**PRODUCT
SUPPORT
BULLETIN # 429**

TOOL(S) \ PRODUCT(S) AFFECTED: 6509-20, 6509-22 Sawzall®, 6519-22 Sawzall Plus®

SUBJECT: 14-67-0135 (Primary) Wobble Plate Assembly

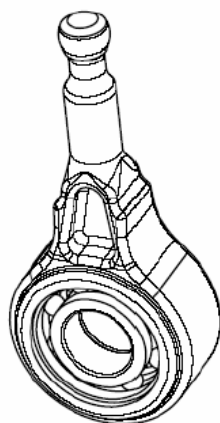
14-67-0135 Wobble Plate Assembly is a new service replacement part for the primary wobble plate used in the 6509-20, 6509-22 Sawzall®, 6519-22 Sawzall Plus®.

14-67-0135 Wobble Plate Assembly features a lip which is formed over the two [2] 02-04-1510 Ball Bearings to trap (hold) them in place, eliminating the internal retaining ring (34-80-2600). The 02-04-1510 ball bearings are not able to be removed and replaced; if there should be a failure (wear-out) of the ball bearings or ball-end stud of the wobble plate, a complete new 14-67-0135 Wobble Plate Assembly must be used.

30-72-0085 Wobble Plate status will remain unchanged for the present as it has other usage – Super & Orbital Super Sawzalls®.

This bulletin is for informational purposes. PLEASE NOTE ON SERVICE PARTS LIST: 54-40-5180, 54-40-5210
